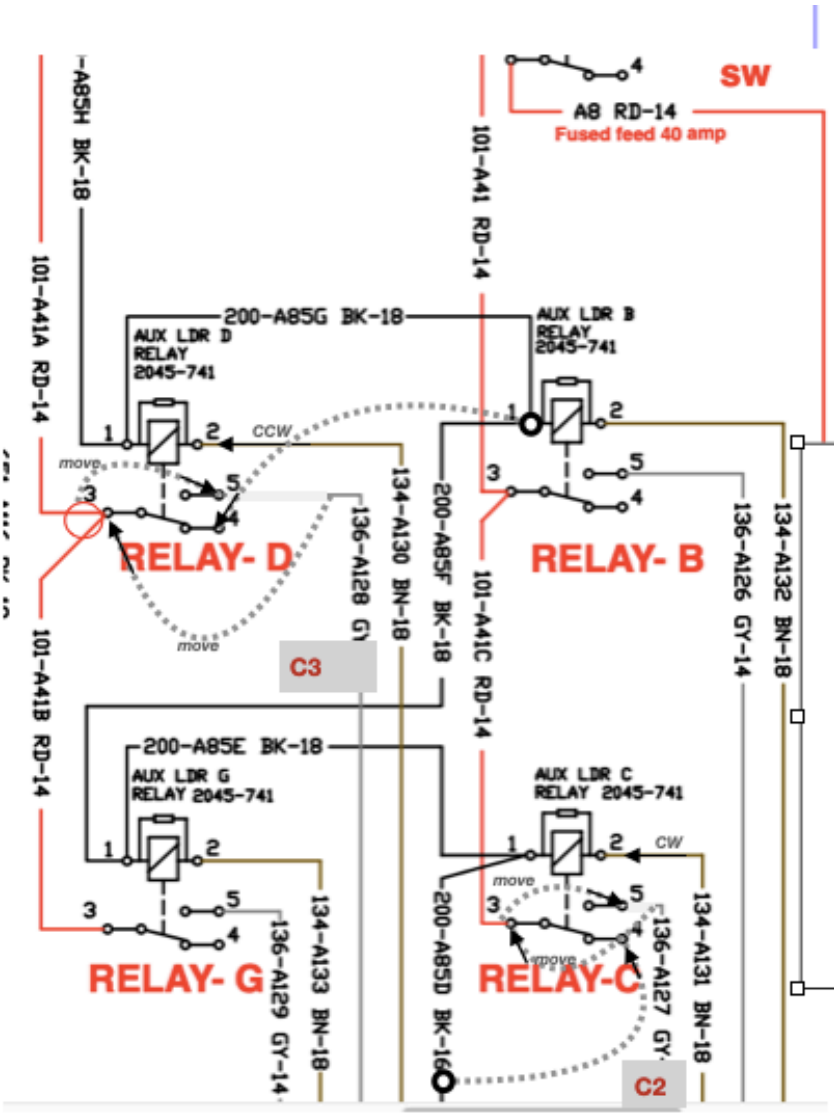
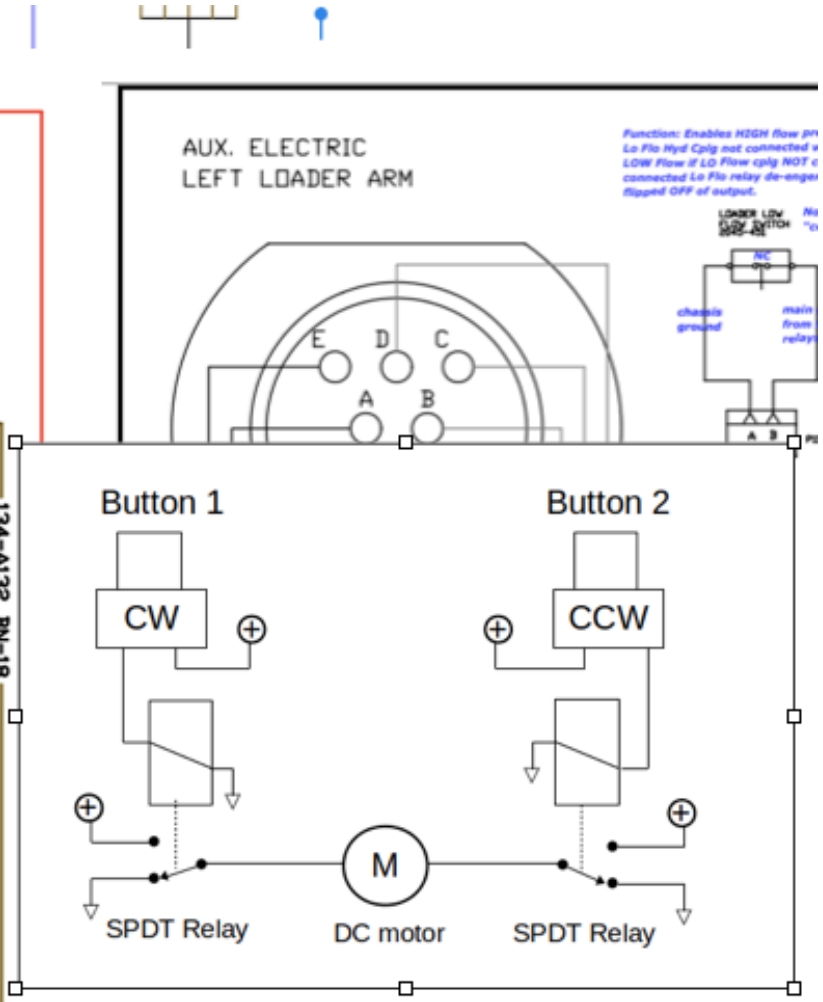
C3 & C2 run directly to motor, #200 is ground:

— Connect a ground wire(200) to each #4 terminal,
— move the fused hot wire from #3 to #5 terminal,
— Remount the C3 & C2 wires from present #5 term. to their respective common switched #3 terminals, DONE.
